# 33/66 kV Inter-array Cables for Dutch Offshore Wind Farms

A review on the TenneT cost benefit analysis and consultation process

**From:** BLIX Consultancy BV  
**Reference:** 20150615\_RVO\_SDB\_Final\_Report\_33\_66 kV\_VF  
**To:** Netherlands Enterprise Agency on behalf of Ministry of Economic Affairs

**Date:** 15-6-2015

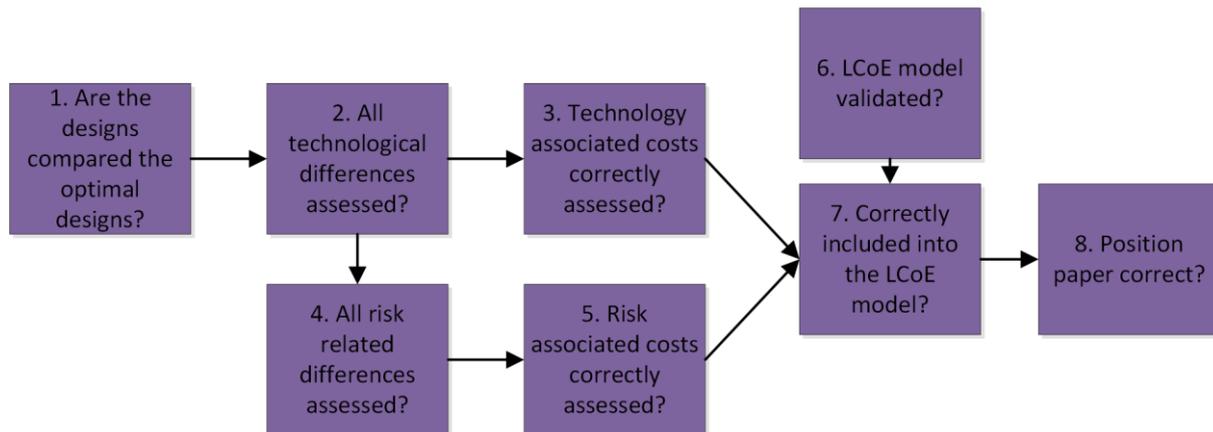
Issue in March version of position paper	Status in final version of position paper
The position paper appeared to have a stringent view on standardization with a fixed design for all five platforms	The current position paper leaves room for incremental innovation in the design, based on lessons learned during the construction of previous platforms
The position paper seemed biased towards 66 kV	More neutral formulation
The conceptual designs for 33 and 66 kV were not optimized, biased towards 66 kV and maybe not appropriate for "Hollandse Kust" tender rounds	Strong analysis in the position paper was added, which assesses the cable impacts for both 33 and 66 kV for all five tender rounds. While still not optimized, BLIX and EnSol agree that the design is not biased towards either voltage level
Cable costing confusing and sometimes contradicting	Clarified in new version of position paper
Often the best case costing data were used in the LCOE analysis	The position paper now uses a range.

The availability of cost effective 66 kV cables was not sufficiently researched	The position paper now includes an analysis
The availability of cost effective 66 kV turbines was not sufficiently researched	The position paper now includes an analysis, which shows that all major turbine manufacturers are able to provide a 66 kV solution. However, only the larger ( $\geq 5$ MW) turbines in the portfolio will most likely be adapted to 66 kV

Figure 2: A schematic depiction of the risk of an unsuccessful tender for a situation with a lower expected value but a higher standard deviation

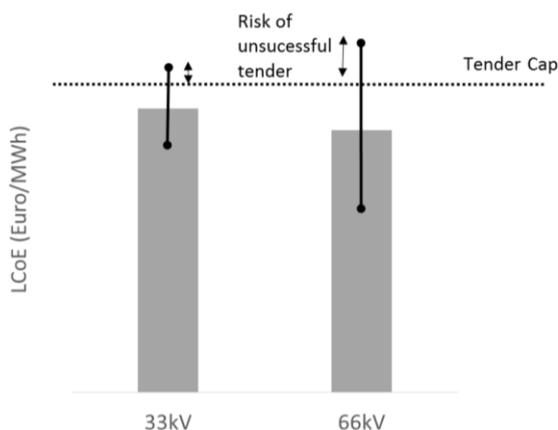
However, the paper does not elaborate on the effects of the risks materializing. BLIX has the opinion that, even though these risks are low, they cannot be completely excluded. Since 66 kV is a new technology, there might still remain a (perceived) market risk of higher priced turbines, unforeseen circumstances and limited availability of reference price information. In the proposed tender system, with a maximum tender cap (above which bids are ineligible) the way these risks are perceived could result in ineligible bids above the tender cap.

This is shown simplified and schematically in the next figure (without realistic numbers). Even though the expected price for 66 kV is lower, the bandwidth for the (perception of the) bid price is higher due to higher uncertainties. In some cases, this could lead to reaching the tender cap, resulting in an unsuccessful tender.
